RFB-2022-59
JAIL KITCHEN CONVEYOR

ADDENDUM #3

Issued Date 6/9/22

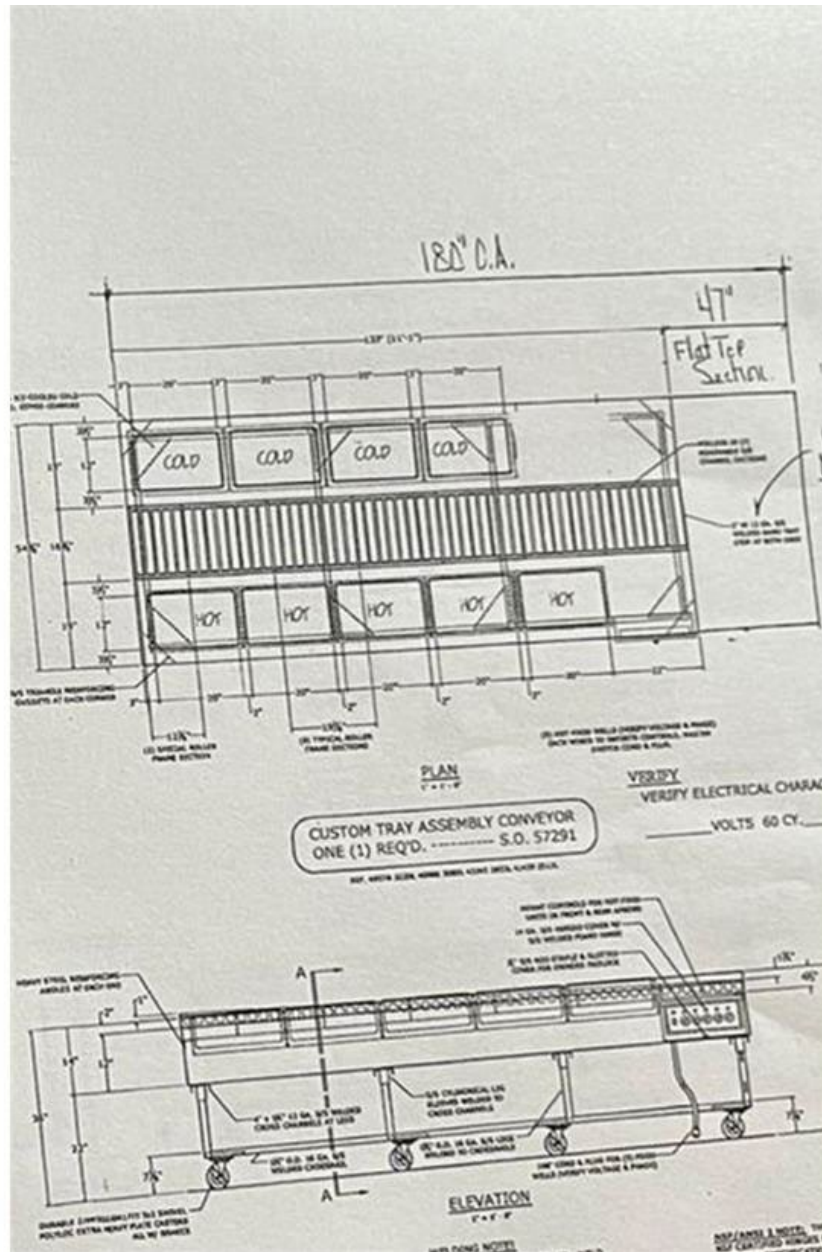
- b. We're not gas techs unfortunately and we want make sure the SOW is just the conveyor.
3. Does the unit need NSF testing done? – **County will look into.**
 - a. All components are stainless steel and NSF listed such as the grey tube(the grey/blue means good for food contact where as white/black are used for drain applications) and Interroll bearings as well which we use everyday in our dish room designs.
4. Should we follow the drawing that was provided to us at the site meeting as the unit you need and **not the unit below**? **Please quote based on drawing provided in this addenda, not the drawing below.**

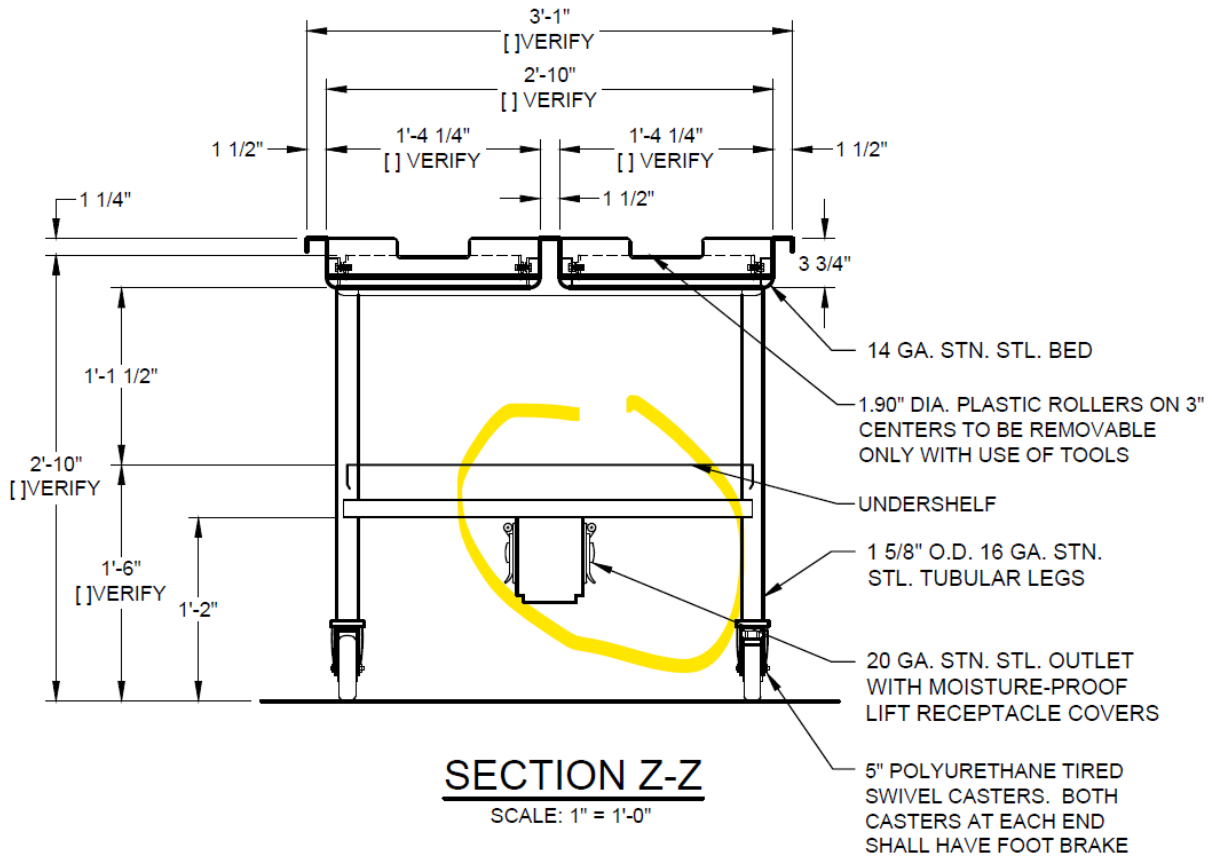
8. IF questions 8 is not correct, is bidder designing the unit FOR the kitchen team to place the HOT/COLD wells with a wire chase(a box and plugs) below ? – see blow of sample pic **Please go off of the attached drawings, not the drawing presented below.**
